PROJECT NUMBER: SP2020-011
PROJECT NAME: Amended Site Plan for Channell Commercial Corporation
SITE ADDRESS/LOCATIONS: 1700 S JOHN KING BLVD

CASE CAPTION: Discuss and consider a request by Mark W. Pross of Pross Design Group, Inc. on behalf of Ed Burke of Channell Commercial Corporation for the approval of an Amended Site Plan for an existing industrial building on an 18.762-acre parcel of land identified as Lot 2, Block A, Channell Subdivision Addition, City of Rockwall, Rockwall County, Texas, zoned Light Industrial (LI) District, situated within the SH-205 By-Pass Overlay (SH-205 BY OV) District, addressed as 1700 John King Boulevard, and take any action necessary.

06/25/2020: SP2020-011; Amended Site Plan for Channell Commercial Corp.
Please address the following comments (M= Mandatory Comments; I = Informational Comments)

TO: Planning and Zoning Commission
FROM: Ryan Miller, *Director of Planning and Zoning*
DATE: July 14, 2020
SUBJECT: SP2020-011; *Amended Site Plan for Channell Commercial Corporation*

1 SITE SCREEN WALL DETAILS

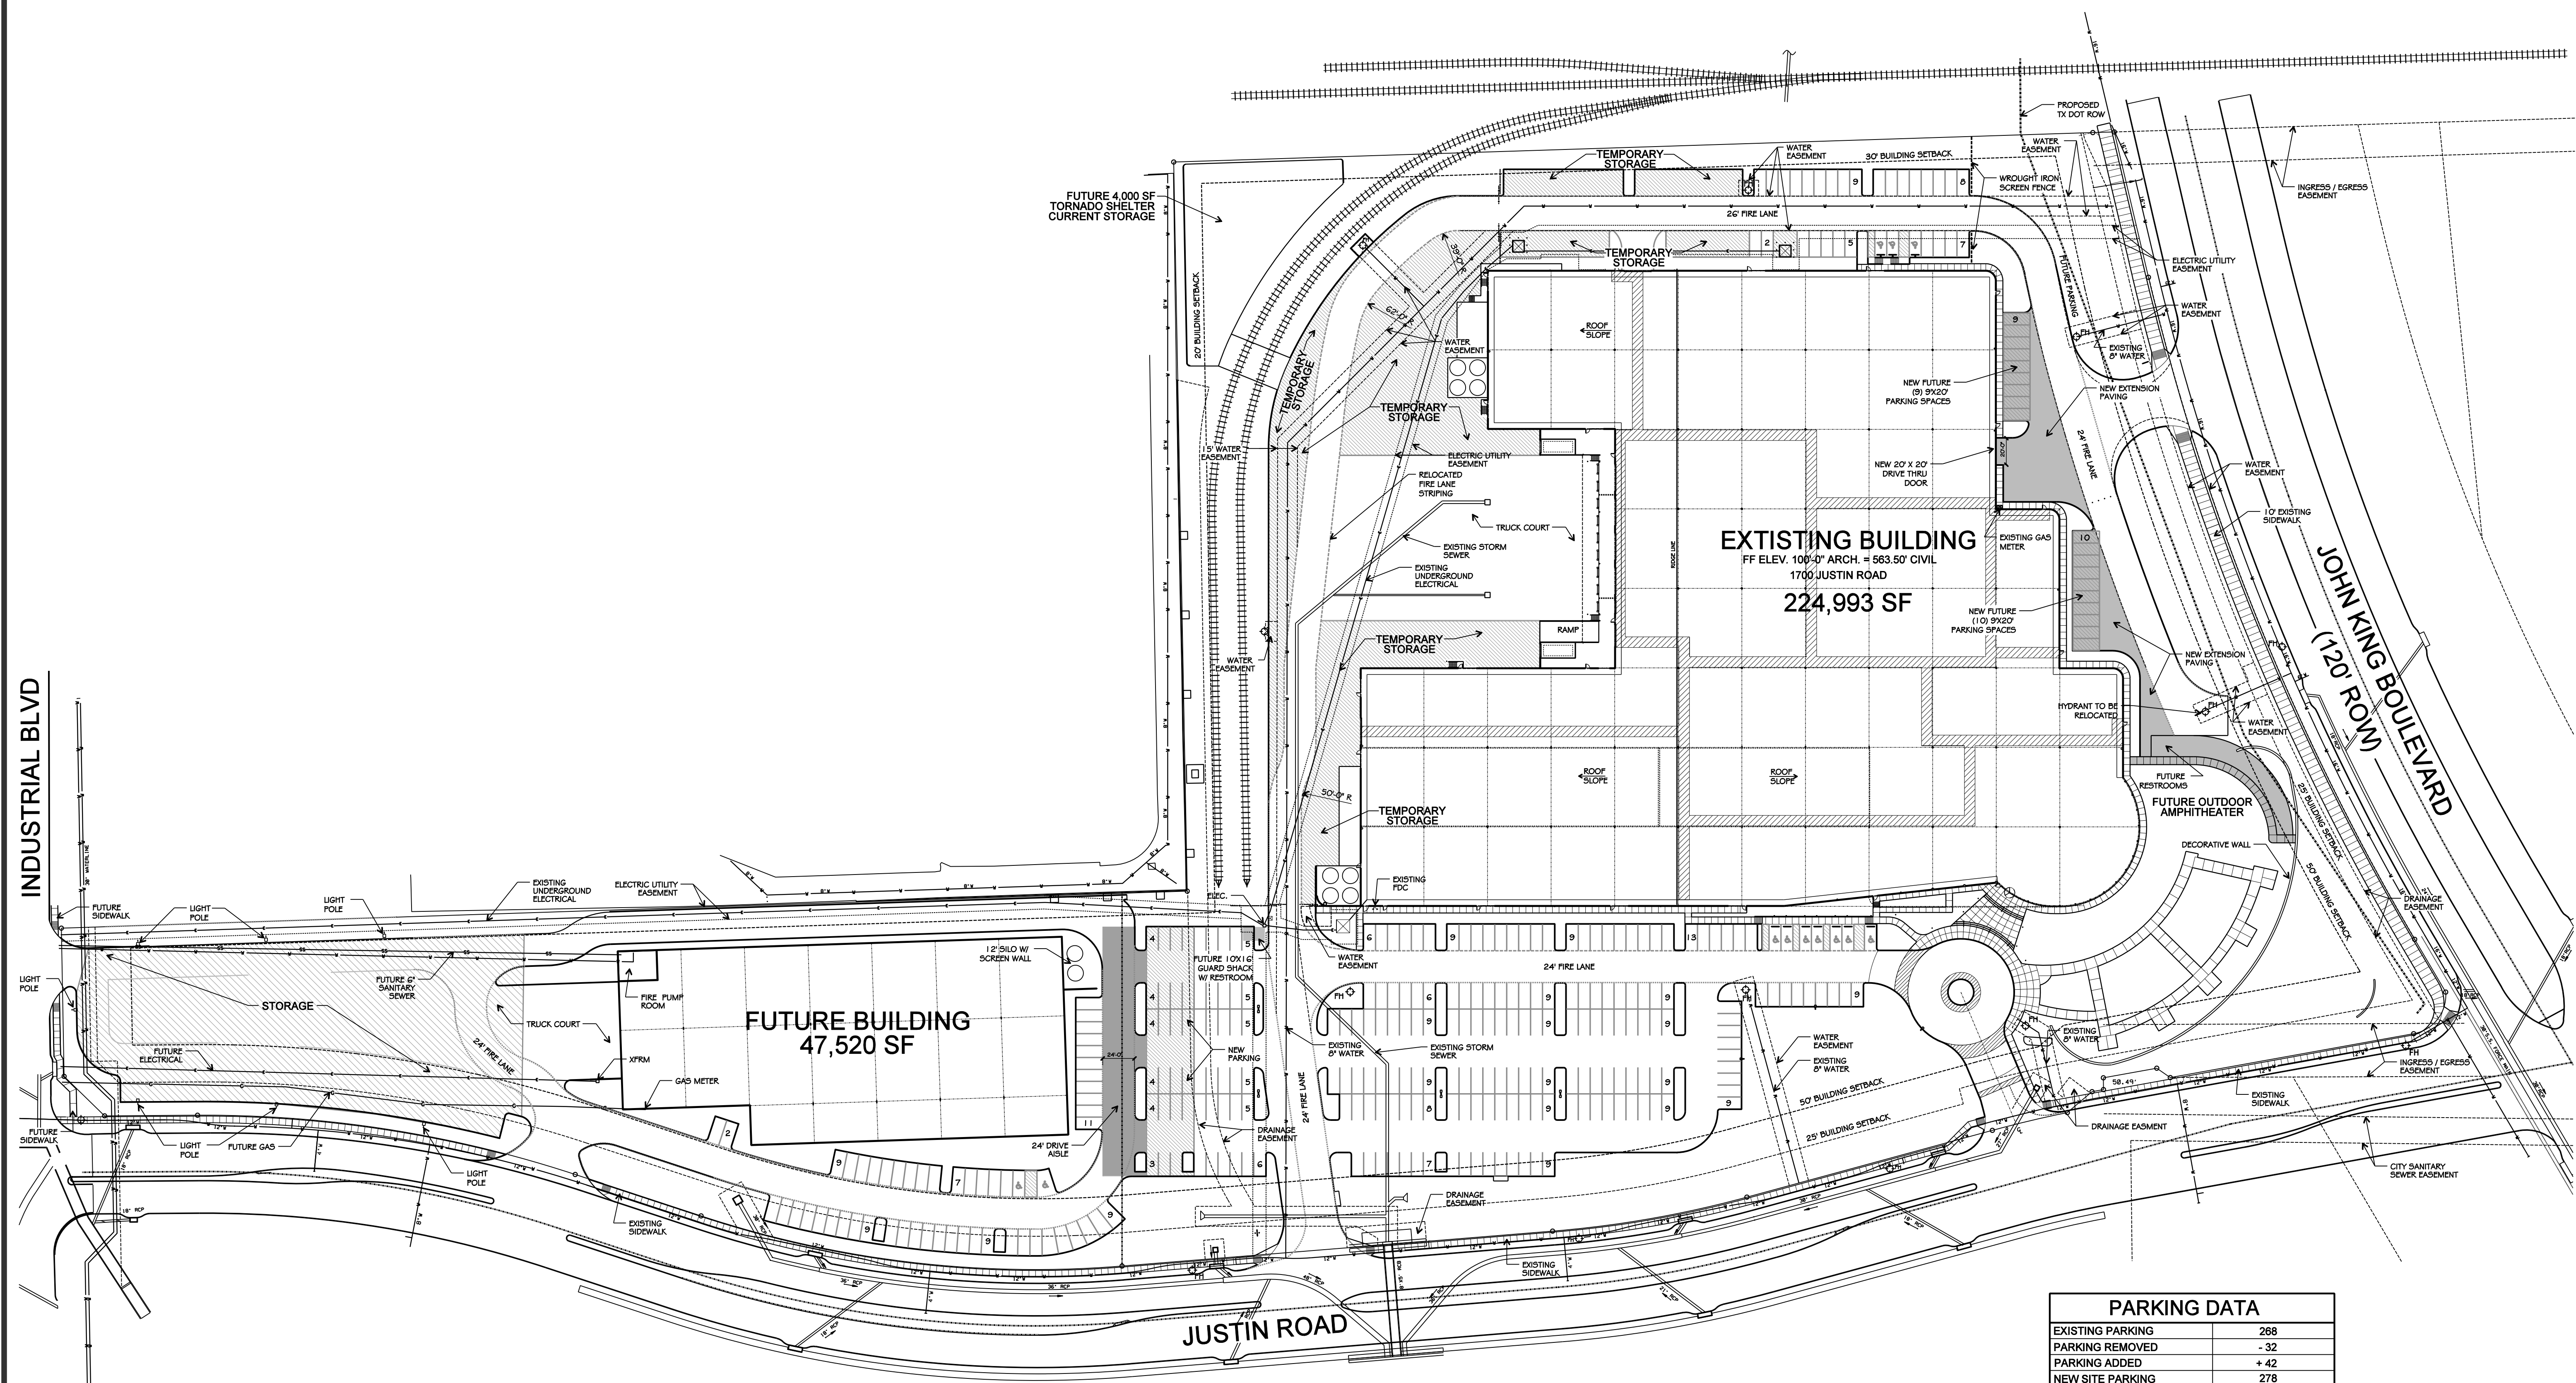
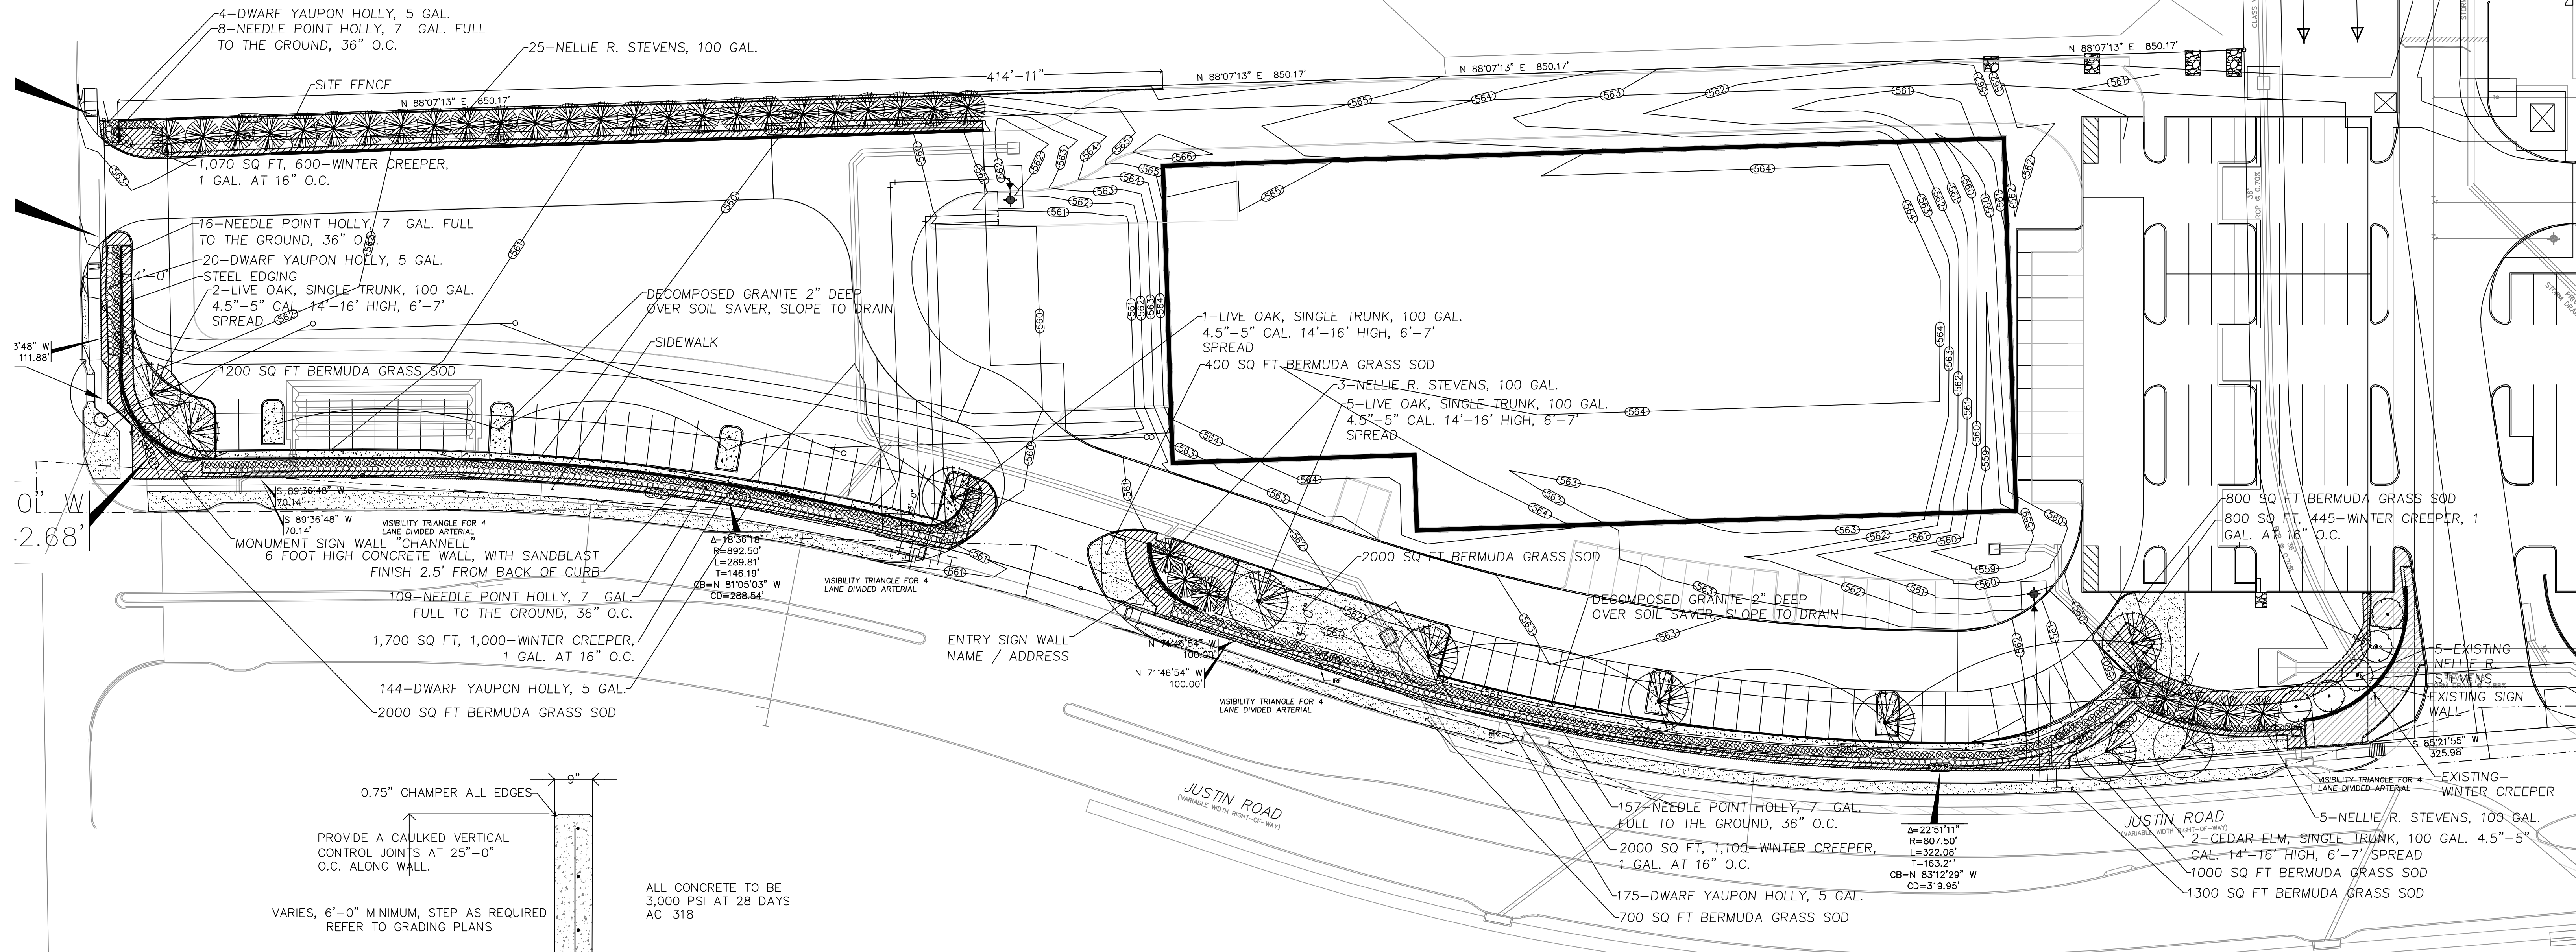
According to the plan, these areas will be screened using an eight (8) foot concrete wall that will be located adjacent to Justin Road and Industrial Boulevard. The wall will be situated approximately ten (10) feet off the property line, and incorporate shrub screening along the entire length of the wall in the ten (10) foot landscape buffer. According to Subsection 08.04, *Non-Residential Fences*, of Article 08, *Landscape and Fence Standards*, of the Unified Development Code (UDC), "(n)o fence shall be constructed in the front yard of a non-residential property without being granted an exception from the Planning and Zoning Commission ... [t]he Planning and Zoning Commission may authorize the issuance of an exception for the construction of a front yard fence subject to the following provisions:

On the north side of the outside storage area (*i.e. the area adjacent to Graham Packaging PET Technologies, Inc.*) the applicant is proposing to utilize 25 x 100-gallon, Nellie R. Stevens and a black vinyl chain-link fence to screen the area. Subsection 05.02(A), *Loading Docks and Outside Storage Areas*, of Article 08, *Landscape and Fence Standards*, of the Unified Development Code (UDC) allows the Planning and Zoning Commission to consider alternative screening that meets one (1) of the following standards: [1] a wrought iron fence and three (3) tiered screening (*i.e. Canopy Trees, Accent Trees and/or Large Shrubs, and Shrubs*) or [2] a wrought iron fence and two (2) rows of staggered mature evergreen trees and one (1) row of canopy trees. In this case, the applicant is screening the outside storage area from the view of Industrial Boulevard and the adjacent light industrial property. While the proposed screening is not exactly what is called for by the Unified Development Code (UDC), it does appear that it will be sufficient to screen the storage areas; however, this is a discretionary decision for the Planning and Zoning Commission.

- (1) The applicant shall apply for all the necessary building permits for the proposed screening fence.
- (2) The *Future Building* depicted on the amended site plan will require a separate site plan submittal and approval.
- (3) A *Photometric Plan* showing conformance to the City's standards will be required to be submitted with the building permit for the screening fence.
- (4) A wrought iron gate shall be used in lieu of a solid screening fence.
- (5) The proposed gate will need to be a minimum of 20-feet back from the public right-of-way to allow off-street cueing of one (1) vehicle.
